FEIR APPENDIX C
COMMENTS ON THE DEIR

AGENCIES
COMMENTS ON THE DEIR

COMMENTS TO REQUEST FOR REVIEW FOR THE DRAFT ENVIRONMENTAL IMPACT REPORT, PLNP2021-00191 COYOTE CREEK AGRIVOLTAIC RANCH PROJECT, SCH#2022010271, SACRAMENTO COUNTY

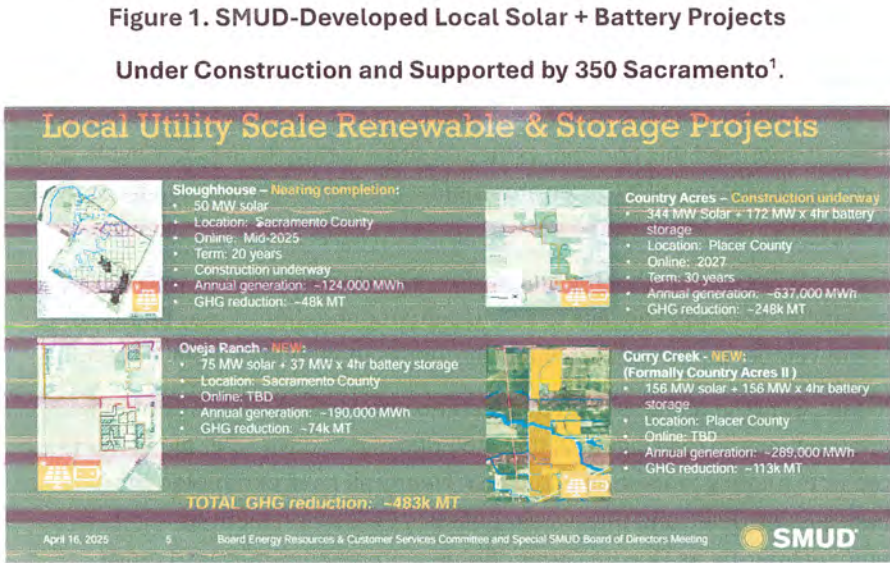
In fact, SMUD maintains a list of generation projects requesting potential interconnection (see Figure 2) that includes eight active solar plus battery projects totaling more than 2,200 MW. Nearly all have completed the necessary studies and three are requesting SMUD connections at the same point of inter-tie as Coyote Creek. Some of these sites may also prove problematic, and some requests may be withdrawn later. But the point is that Coyote Creek is neither unique nor irreplaceable.

The draft EIR asserts that Coyote Creek's primary goal is to assist SMUD in meeting its carbon reduction goals. But the project is not at all necessary for the ultimate success of SMUD's Zero Carbon Plan.

Figure 1. Location and extent of blue oak woodlands within and near the proposed Project area. Map prepared for Sierra Club.

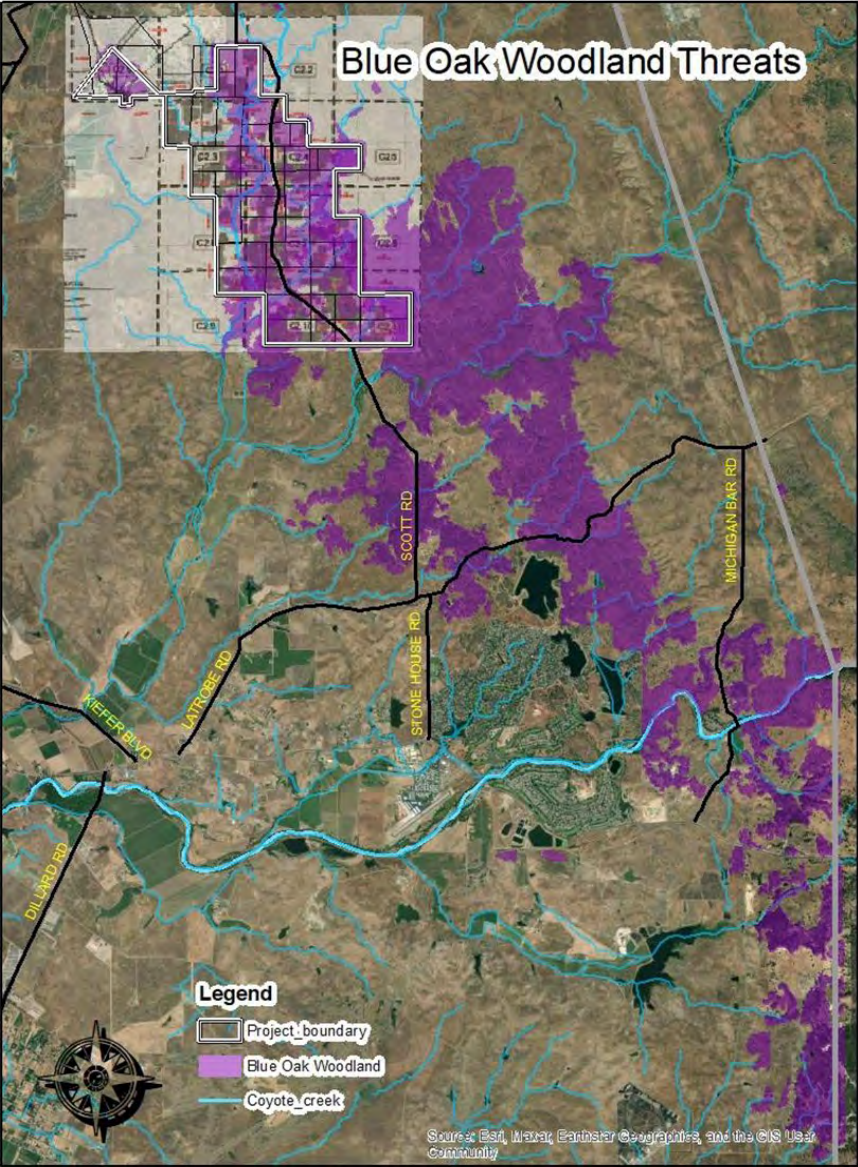
The proposed Project site supports many species of native trees, notably the blue oak, interior live oak, valley oak, unidentified oak species, and Fremont cottonwood (see Figures 1 and 2, which show the location and extent of blue oak woodlands within and around the proposed Project area). The DEIR (DEIR, p. 6-11–12) states that an inventory of all trees within the solar development area and proposed Project site was conducted, but later states that the entire proposed Project site was not surveyed for individual trees (DEIR, 6-13), implying that there are more trees than reported. **The inventory of all native trees within the proposed Project site must be provided to give the public an understanding of the significant impact of the loss of native trees.**

woodlands with a canopy cover at or above 10% have dwindled to ~3% of their previous range, and this project alone would remove 30% of this small remainder.

Figure 3. Location of the Project area in relation to connectivity corridors.

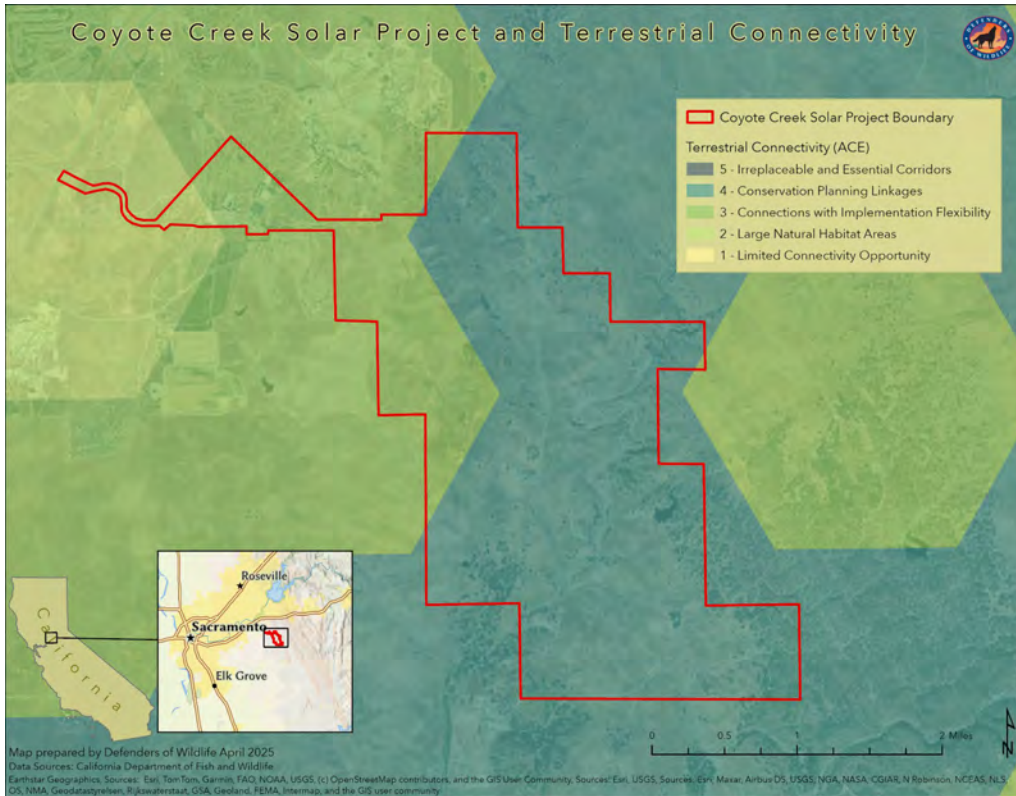
We concur with the described important east-west and north-south designated wildlife corridors in the DEIR (Plate BR-3, DEIR, p. 6-32). The effects of the proposed Project on the function of these corridors form a major basis for our concern about the project. If approved, the proposed Project would add to the significant cumulative loss of lands with natural cover within the Sacramento region, including the loss and fragmentation of habitat with high and moderately high intactness. The DEIR must address the effects of this disruption on movements of individual animals and on the demographics and genetics of populations. The analysis must be conducted cumulatively to recognize recent and proposed projects that would, along with the Project, substantially reduce connectivity in the surrounding region and commit to comprehensive planning to maintain connectivity to the greatest possible degree.

We present maps from the SSHCP the proposed Project area in relation to priority corridor areas in eastern Sacramento County (Figure 3), terrestrial intactness of the land (Figure 4), and terrestrial biodiversity (Figure 5).

Figure 5. Location of the Project area in relation to terrestrial biodiversity.

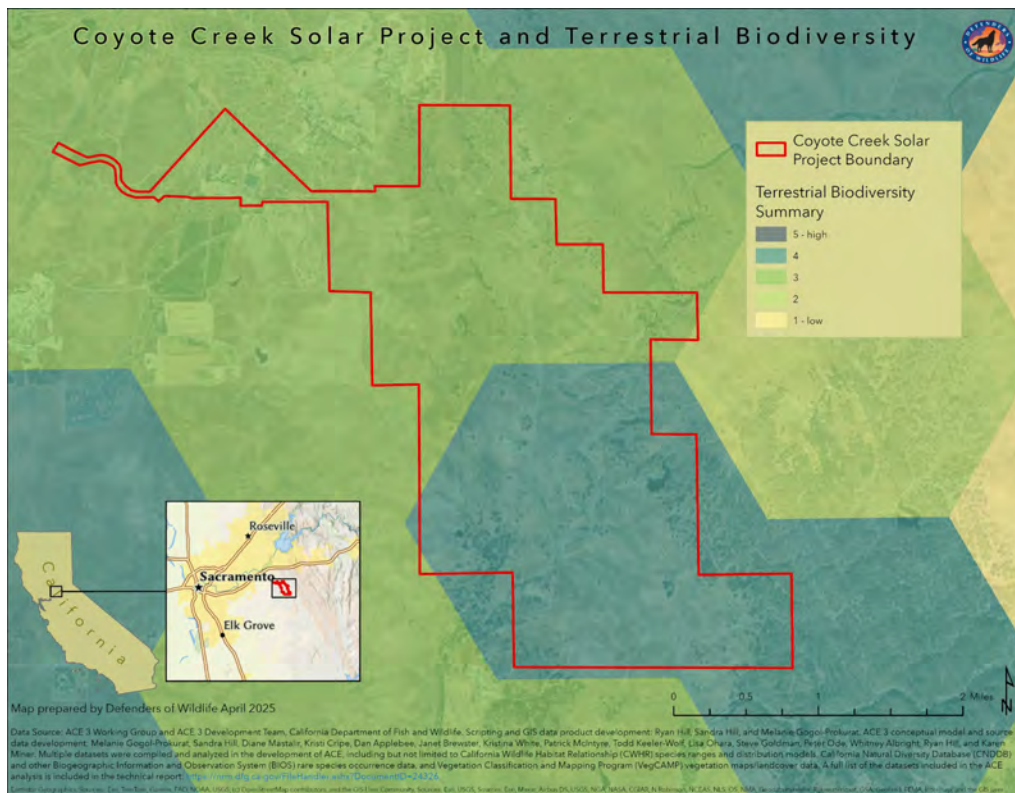
While habitat compensation that occurs elsewhere may partially offset habitat losses to regional populations, it is not reasonable to conclude that it would contribute to maintaining connectivity onsite. The effects of the proposed Project on connectivity can be reduced, but not eliminated or adequately mitigated.

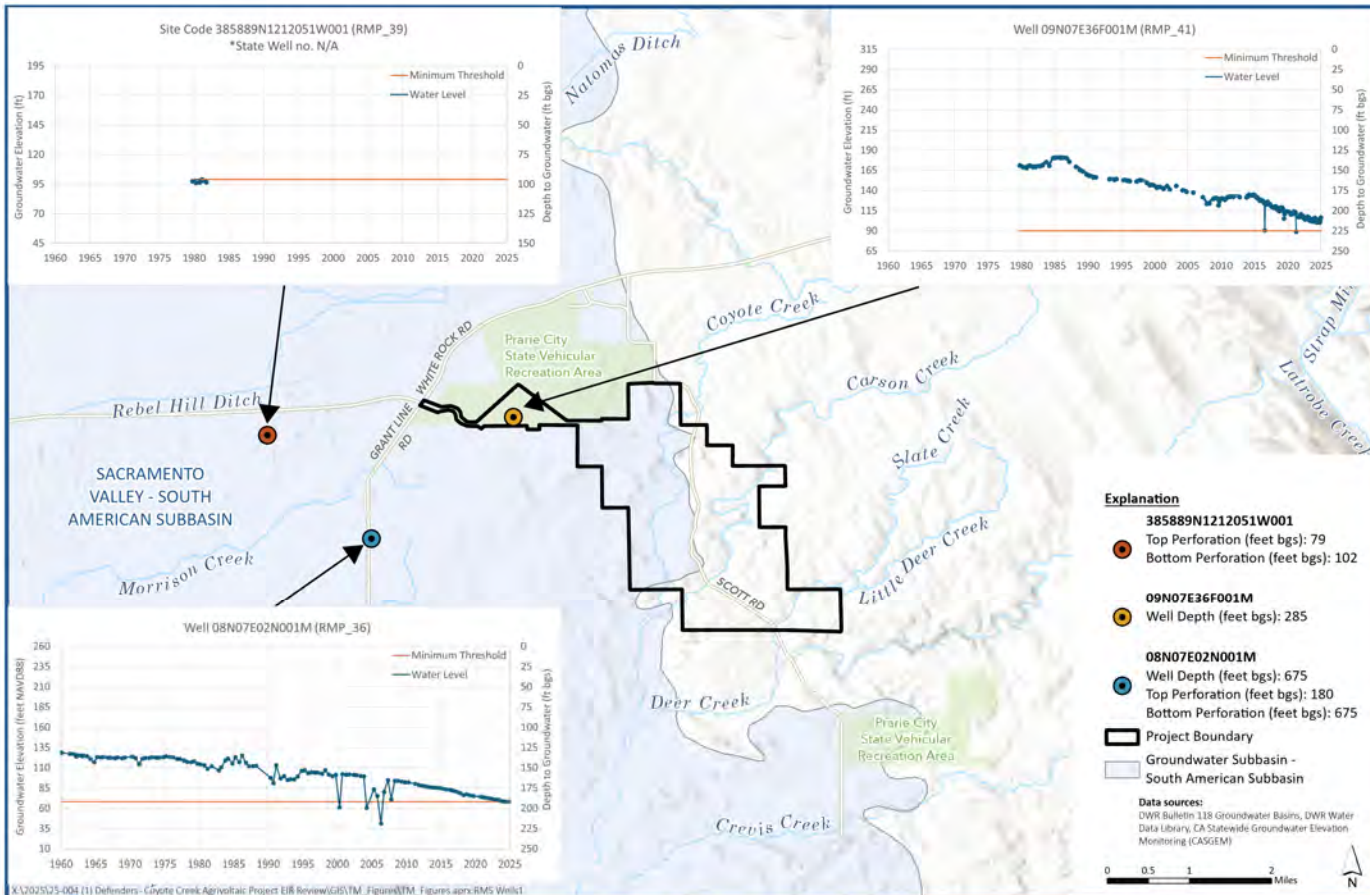
Concerns related to the adequacy of the DEIR in evaluating potential impacts from the Project on stormwater runoff and groundwater recharge under Impacts HYD-2 and HYD-3, groundwater quality under Impact HAZ-2, and groundwater levels and GDEs under Impact HYD-2, are discussed above; however, these concerns also relate to Impact HYD-4 and potential conflicts with the GSP. Groundwater level data presented in the DEIR (see **Figure 2**) also indicate the presence of shallow groundwater conditions in the vicinity of the Project site and therefore potential for interconnectivity between groundwater and surface water resources that exist on or near the Project site. The DEIR should

incorporate and consider local groundwater level conditions (including shallow groundwater level data presented in the DEIR) in conducting a robust assessment of potential ISW resources in the vicinity of the Project and potential for the depletion of any surface water resources by groundwater pumping proposed for the Project. The DEIR indicates that boreholes proposed to be potentially used to supply groundwater for the Project have shallow groundwater levels and are in close proximity to Carson Creek (see **Figure 5**). Although the South American Subbasin GSP did not identify any likely ISWs near the Project site, the analysis of ISWs for the GSP was conducted at a regional scale with more limited groundwater level data and likely do not accurately reflect site-specific conditions at or near the Project.

Figure 4

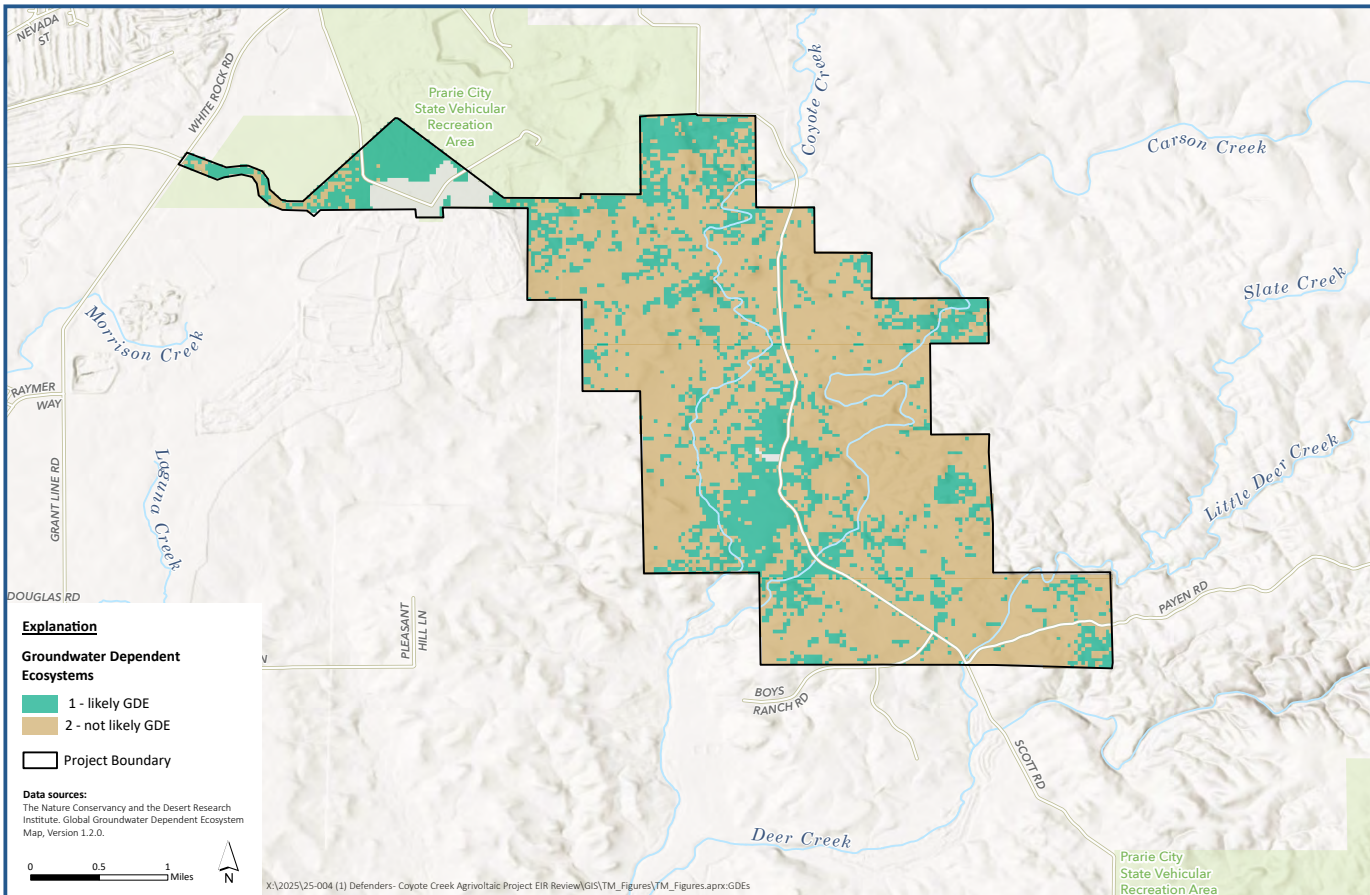
Figures 3 and 4 present maps of potential GDEs in the vicinity of the Project site based on data published by The Nature Conservancy (TNC). **Figure 3** shows the locations of potential GDEs from the Natural Communities Commonly Associated with Groundwater dataset (NCCAG) (TNC, 2025a) developed by TNC with the intent to be used as a starting point for the evaluation of potential GDEs in areas across the State of California. **Figure 4** presents data from the Global Groundwater Dependent Ecosystems Map developed by TNC and the Desert Research Institute (DRI)(TNC and DRI, 2024) and the results from a machine learning approach to evaluate potential GDEs based on consideration of satellite data on a variety of characteristics relevant to identification of GDEs including vegetation and water indices, temperature, climate, and topography. The machine learning approach used in developing the Global GDE Map
